**MOUNTAINVIEW POWER PLANT PROJECT
SUPPLEMENTAL RESPONSES
TO FIRST SET OF DATA REQUESTS
(00-AFC-2)**

Technical Area

Air Quality

***** Ammonium (ug/m3)

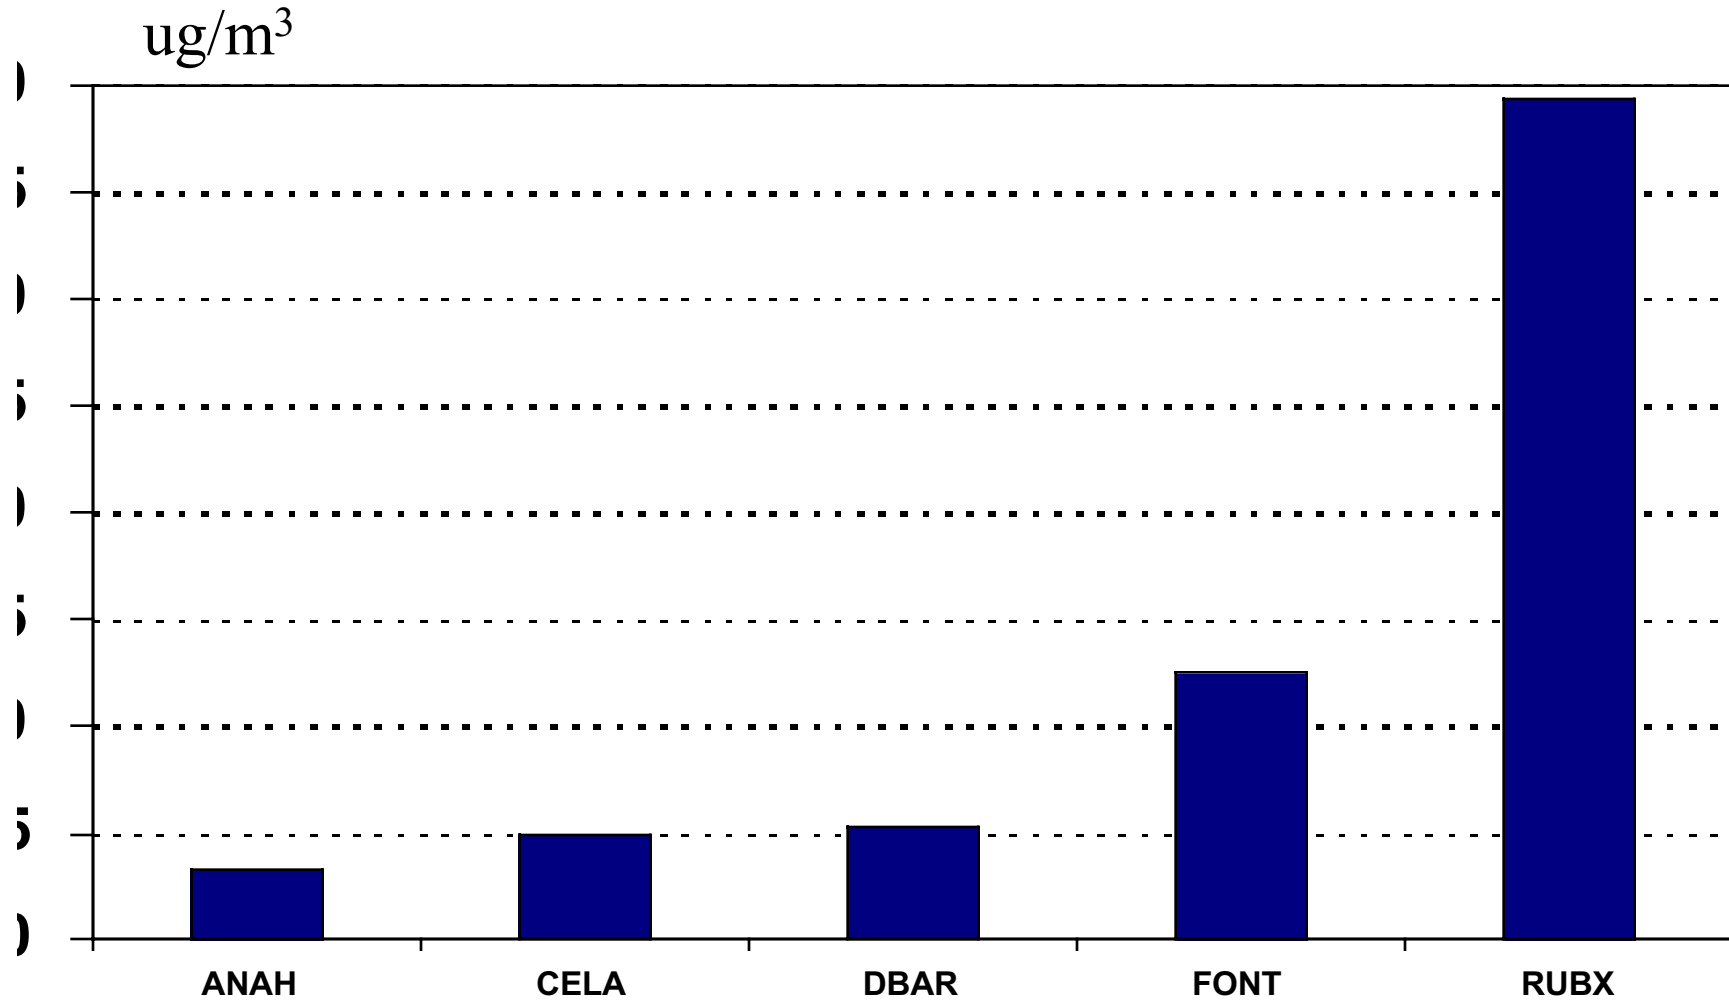
PM10 ammonium concentrations for the 1995 episode days are summarized in the following.
One power point file is attached that contains the annual average ammonia and nitric acid concentrations. This file will help you defend the claim that the inland area is ammonia-rich.

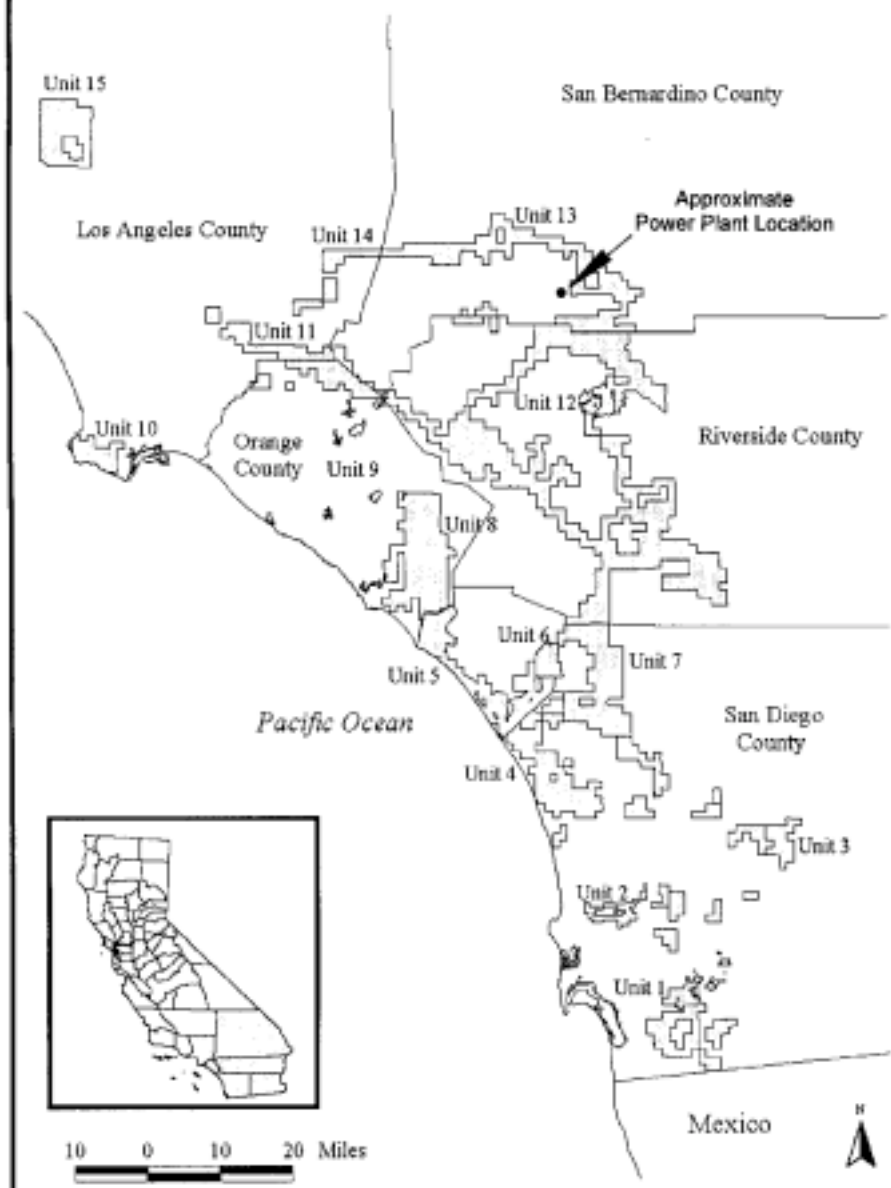
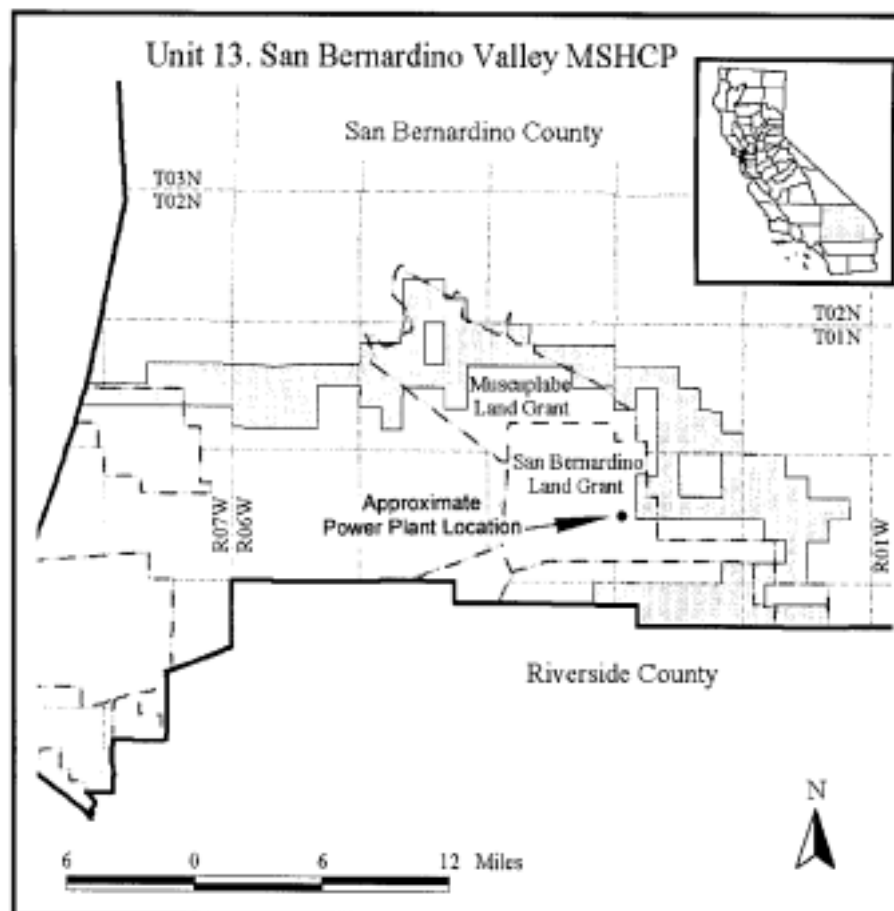
19. Please identify the location of California gnatcatcher proposed critical habitat in relationship to all proposed project features, and the potential for direct, indirect and cumulative impacts on the critical habitat.

According to USFWS Federal Register dated February 7, 2000 (Vol 65, Number 25) page 5952 and associated maps, the project area is located in Unit 13 of the proposed critical habitat of the Coastal California gnatcatcher. The proposed critical habitat maps are included as Attachment BIO-19A. As indicated on the maps and in the description provided on page 5952, neither the plant site nor the proposed natural gas pipeline route fall within the boundaries of Unit 13 of the proposed critical habitat. Based on the description provided on page 5952, the nearest proposed critical habitat to the plant site is located on Norton Air Force Base (currently San Bernardino International Airport). Based on the available information, the assessment of direct and indirect impacts to the Coastal California gnatcatcher species, as presented in our original response to data request #19, does not change.
